CITY OF MITCHELL
CITY PLANNING COMMISSION AGENDA
COUNCIL CHAMBERS, CITY HALL, 612 N MAIN ST
JUNE 8, 2020, 12:00 PM (NOON)

**CITY OF MITCHELL
CITY PLANNING COMMISSION MINUTES
May 26, 2020**

RE: Drainage Review for Lot 10, Westwood Addition
Mitchell, South Dakota
SPN #10809

EXHIBIT C

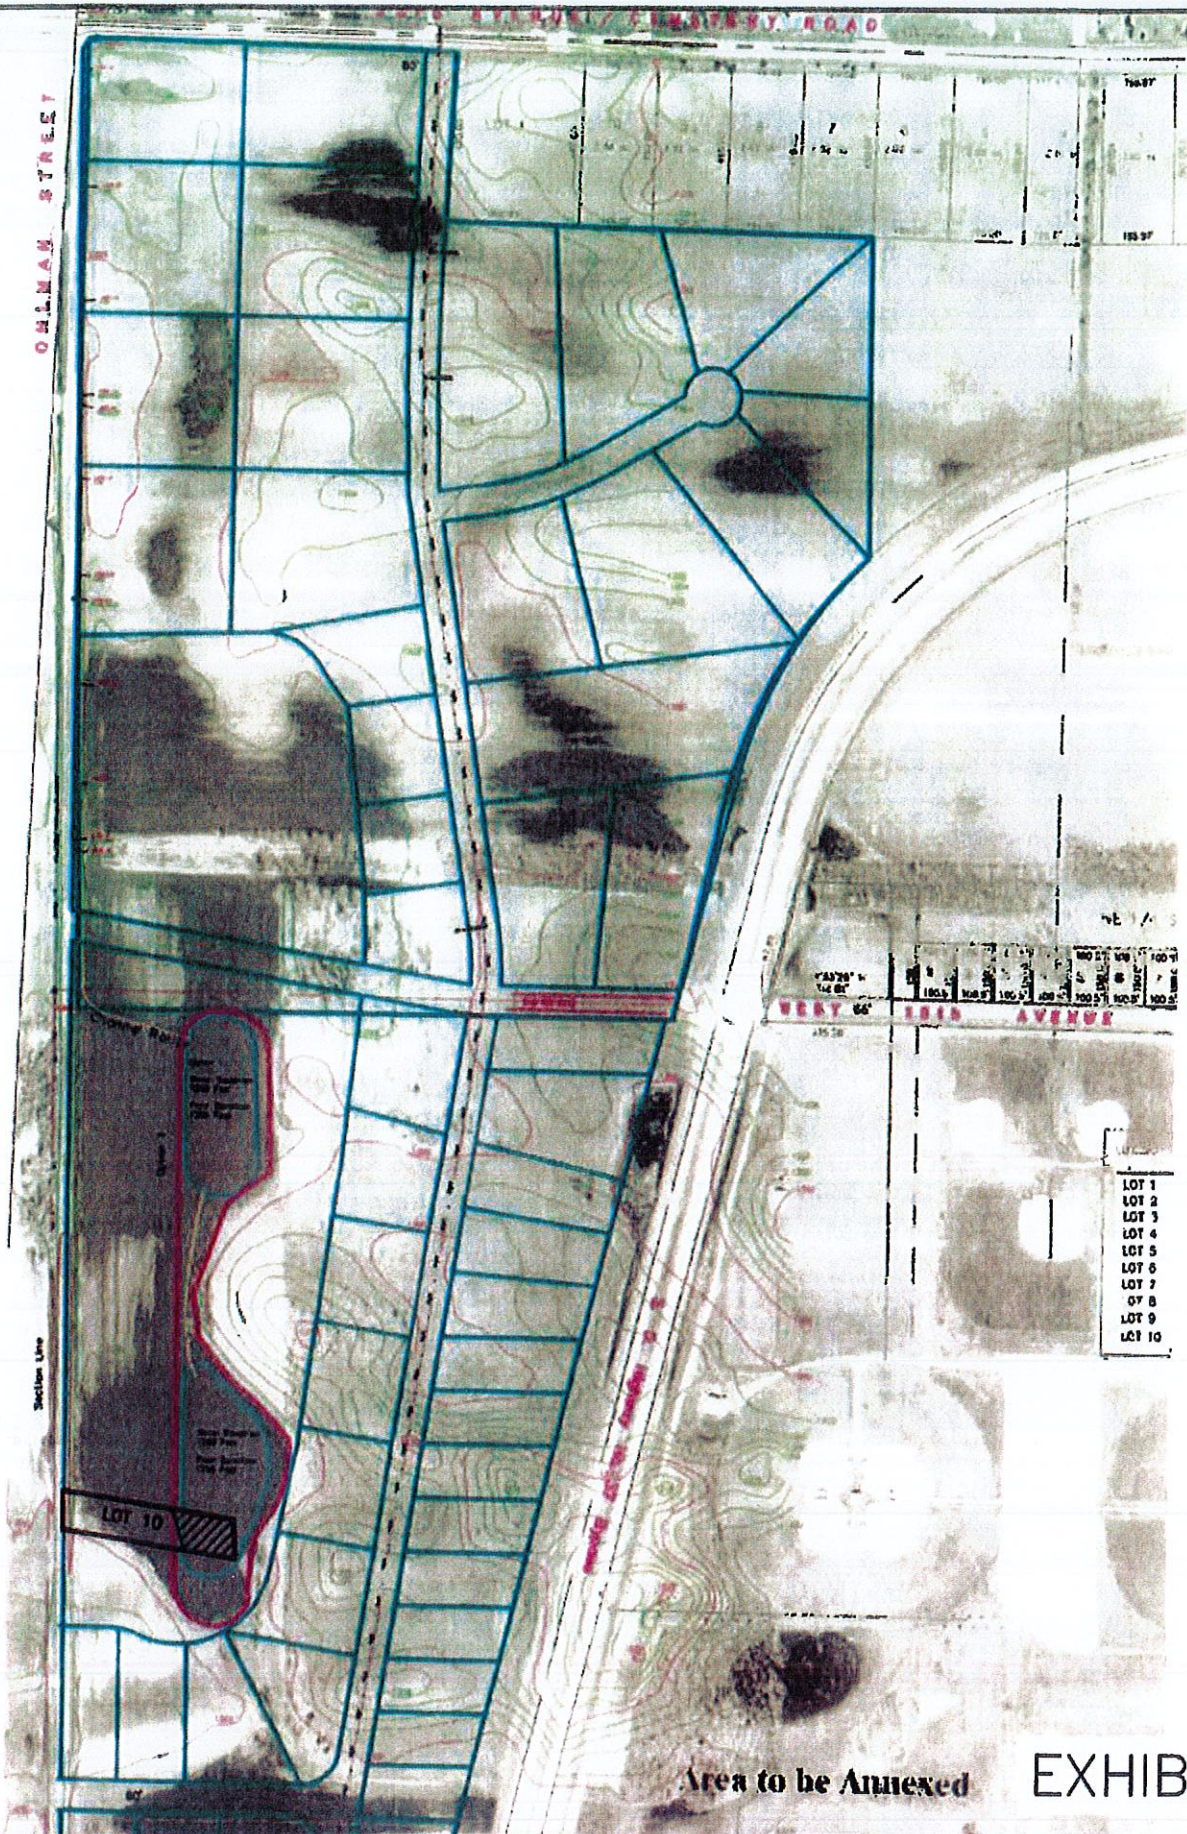
7. The revised Master Plan provided in Exhibit A has been shown on the proposed plat of Lot 10, see Exhibit C. The storm water area shown in the revised Master Plan is consistent with the location of the proposed drainage easement. The elevations collected indicate that there may be additional grading completed to meet the required design capacity; however, the bottom of the existing low area was not recorded due to the water conditions.
8. The original drainage plan as provided in the 2003 study has been overlaid on the proposed plat, see Exhibit D. The drainage easement shown in Lot 10 falls within close proximity of the footprint of the original master drainage plan shown from 2003.
9. The recorded ground elevation at the witness monuments were 1303.46 and 1303.30, well above the potential highwater elevation of 1297.90 described in Item 4.
